ADDENDUM NO. 1
Nebraska State Patrol Troop A - HVAC Renovation
4411 S 108th Street
Omaha, Nebraska - 2012
November 2012 / OA Project No. 012-0684

DATE OF ISSUANCE: December 13, 2012

The Project Manual and Project Drawings dated November 2012, for the above referenced project, are amended by this addendum.

FIRST & GROUND FLOOR MECHANICAL DEMO PLANS
 NEBRASKA STATE PATROOL TROOP A
 HVAC RENOVATION

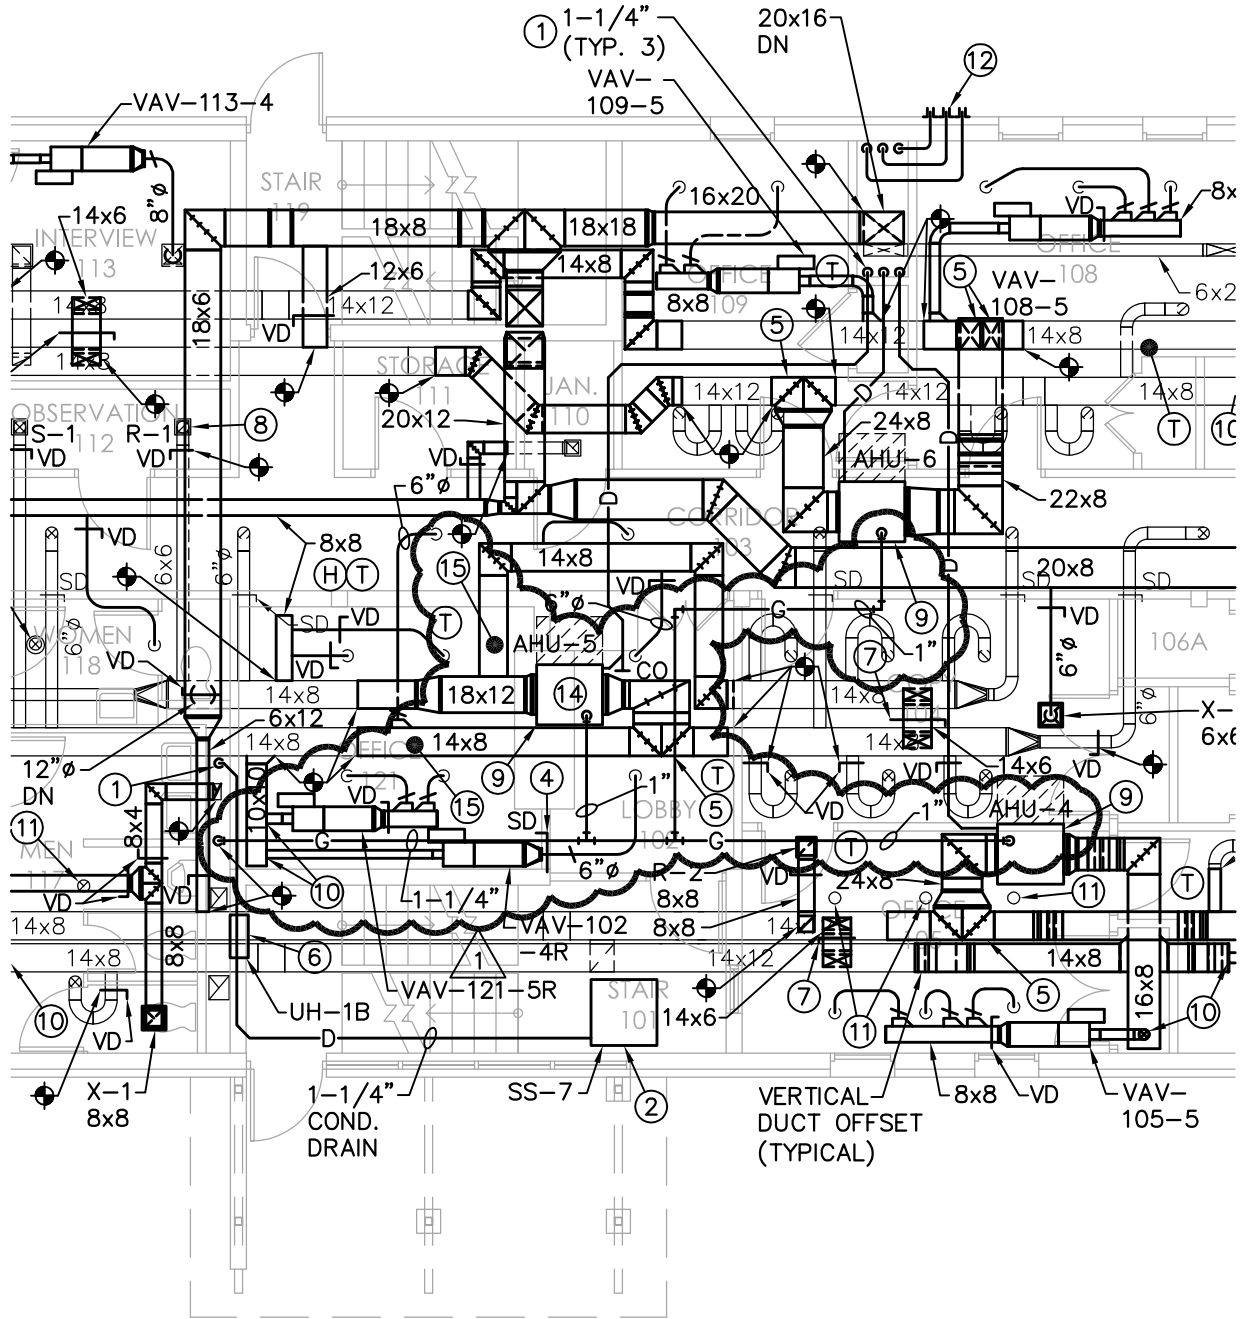
8) Refer to Sheet MD-1 – First and Ground Floor Mechanical Demo Plan

See attached MD-1-1. Demo gas piping on first floor.
